**Re: Market Rules:**

- **Appendix 4.2 – Requirements for Generation Facilities Connected to the IESO-Controlled Grid**
- **Appendix 4.3 – Requirements of Connected Wholesale Customers and Distributors Connected to the IESO-Controlled Grid**

OPG's comments are:

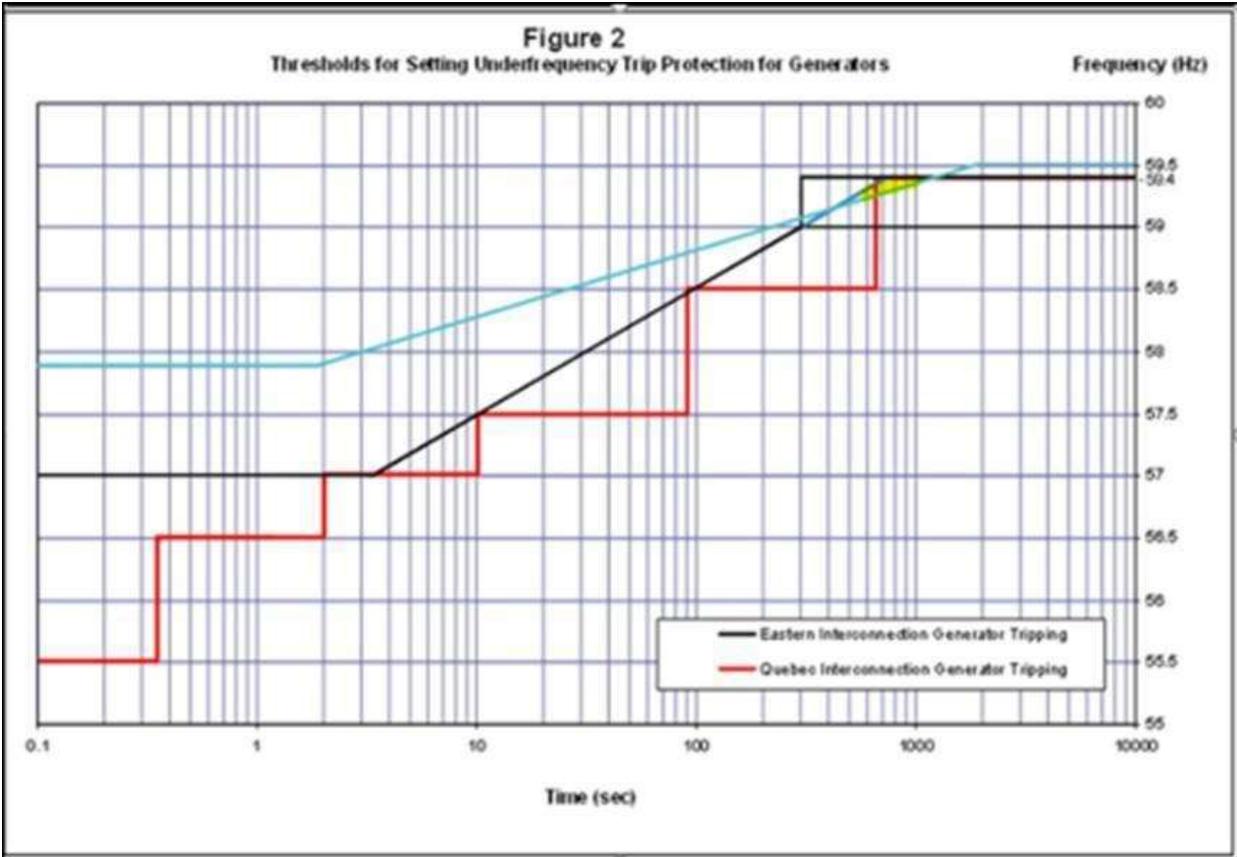
There is a gap in the area for continuous operation and there can be cases where market participants will follow the IESO Market Rule yet will not be in compliance with the NERC Reliability Standard requirements pertaining to frequency protective relay settings.

The area highlighted in yellow on the graph below illustrates where the IESO requirements are less stringent than NERC requirements. By tripping the generating units in this area, Market Participants are compliant with the IESO Market Rules and non-compliant with the NERC requirements.

OPG would like clarification on why the IESO is introducing Market Rule requirements that are less stringent than the NERC Reliability Standard requirements pertaining to frequency protective relay settings.

Additionally the Market Manual 2: Market Administration Part 2.20: Performance Validation, 3.1 Off-Nominal Frequency Operation should be revised to reflect the “do not trip region” that cannot be defined by colored graphs without properly defining the mathematical functions for the boundaries of the domain region.
